Recall Bulletin

SUBJECT: Roof Carrier Retaining Nut Interaction with Roof Rail Airbag

MODELS: 2015 Chevrolet Suburban, Tahoe
2015 GMC Yukon, Yukon XL

GM Recall #14359

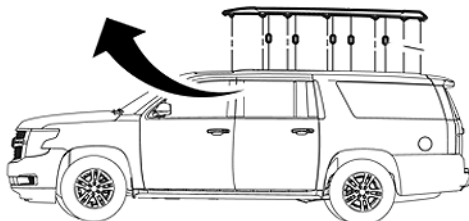
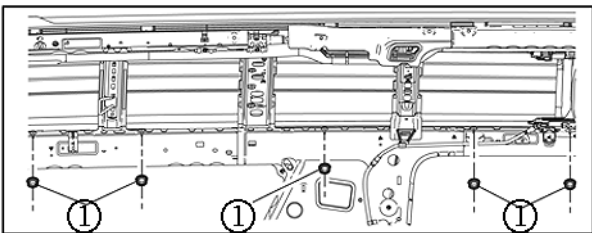
Certain 2015 Chevrolet Tahoe/Suburbans and GMC Yukon/Yukon XLs were built with a combination of roof carrier retaining nut and roof rail airbag (RRAB) that may create holes or tears in the RRAB upon deployment. If a hole or tear is created during deployment, the RRAB may not meet internal GM requirements for cushion integrity. This may increase the risk of full or partial ejection in rollover events or increase the risk of injury in multiple impacts.

Dealers are to replace all of the roof carrier retaining nuts using a different type of retaining nut and adding a cap over the end of each stud.

1. Remove the luggage carrier side rail retaining nuts (1) from both sides of the vehicle. Refer to *Luggage Carrier Side Rail Replacement* in SI, and only complete the underside fastener removal and install portion of the procedure.

2. Install the new luggage carrier side rail retaining nuts and caps as shown above. Refer to *Luggage Carrier Side Rail Replacement* in SI.
